Reference: 92201802-FA

Field Safety Notice - Important Medical Device Information
Capio™ Suture Capturing Devices (SLIM, Standard, Open Access, RP)
Uphold LITE with Capio™ SLIM Vaginal Support System
Pinnacle™ Anterior Pelvic Floor Repair Kit
Pinnacle LITE Posterior with Capio SLIM Pelvic Floor Repair Kit

Root Cause Investigation:

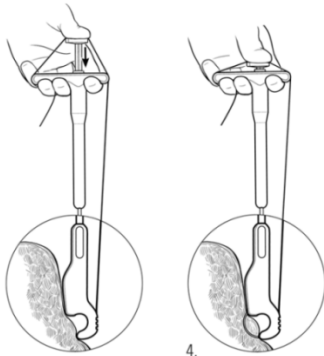
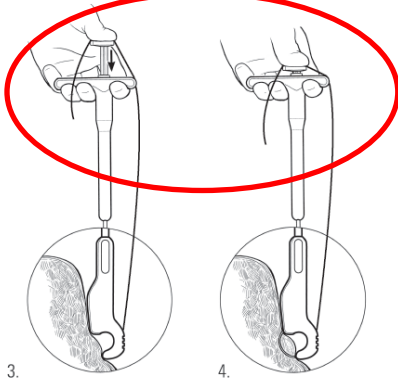
If the Capio suture or pelvic floor kit mesh assembly is placed under excessive counter-traction during deployment, it can result in an interaction between the suture and the Capio carrier that could potentially damage the suture and may cause the dart to detach. The testing confirmed that higher amounts of counter-traction (tension) placed on the Capio suture or pelvic floor kit mesh assembly during deployment contributes to an increased likelihood of damage to the Capio suture and potential Capio dart detachment.
